City of West Linn
PRE-APPLICATION CONFERENCE MEETING
SUMMARY NOTES
April 15, 2010

SUBJECT: Key Bank at 19080 Willamette Drive

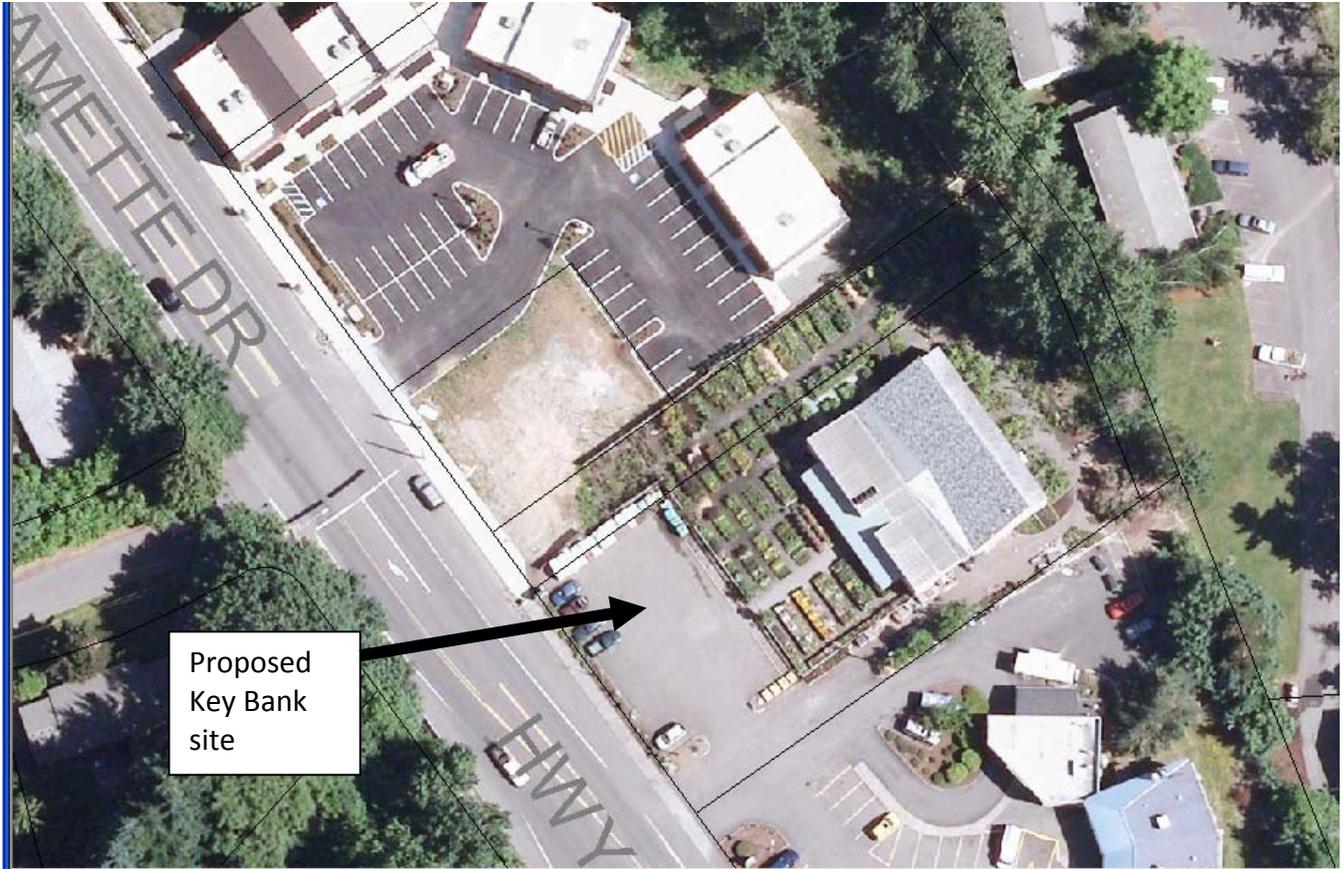
The applicant asked whether the landscaped median strip could be less than 5 feet. CDC 54.020(E)(3)(b)(d) requires landscaped strips to be at least five feet wide. This criterion also requires that parking areas adjacent to the property perimeter be at least five feet wide. To allow a reduced width or to eliminate some, or all, of the landscaped median would require a Class II Variance. Please refer to CDC Chapter 75 for the approval criterion.

©2010 K&B DESIGN ARCHITECTS, P.C.
KEY BANK: MARTLBURST
1500 WILLAMETTE DRIVE
WEST Linn, OR 97068
DRAWING NO: 3
APRIL 1, 2010
PROJECT NO: 207251.05

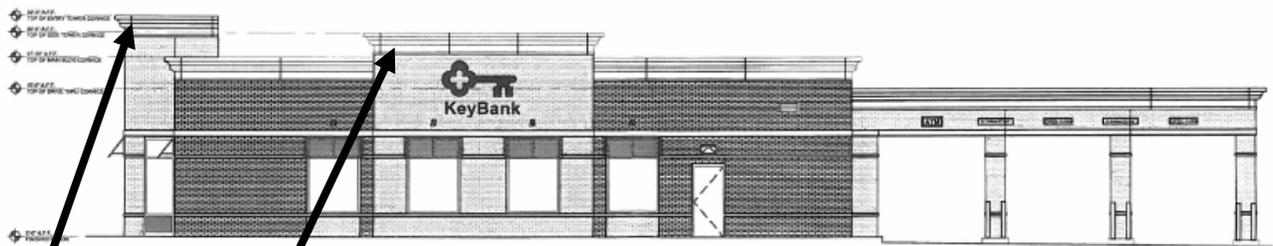
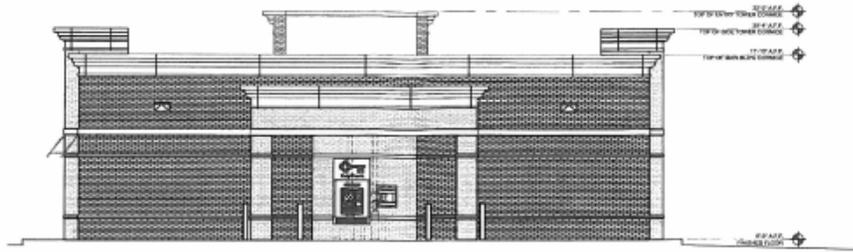
The design submitted by the applicant is a single story building clad in brick with a cornice wrapping around the upper edge of the roof. There are pop-out/bumps on the front and side elevations. While the bump-outs are fine, Staff would like to see the associated false front/raised parapet features eliminated on all elevations. This false front/raised parapet design can be seen at numerous locations in the Portland Metro area and although these designs were acceptable at a particular time and place, they have become outdated and repetitive. The fact that this design is repeated so often in this region means that it would be difficult for West Linn to project itself, through this design, as a unique place.

Staff would like to see the elimination of these parapets and drop it down to the level of the dominant roofline.
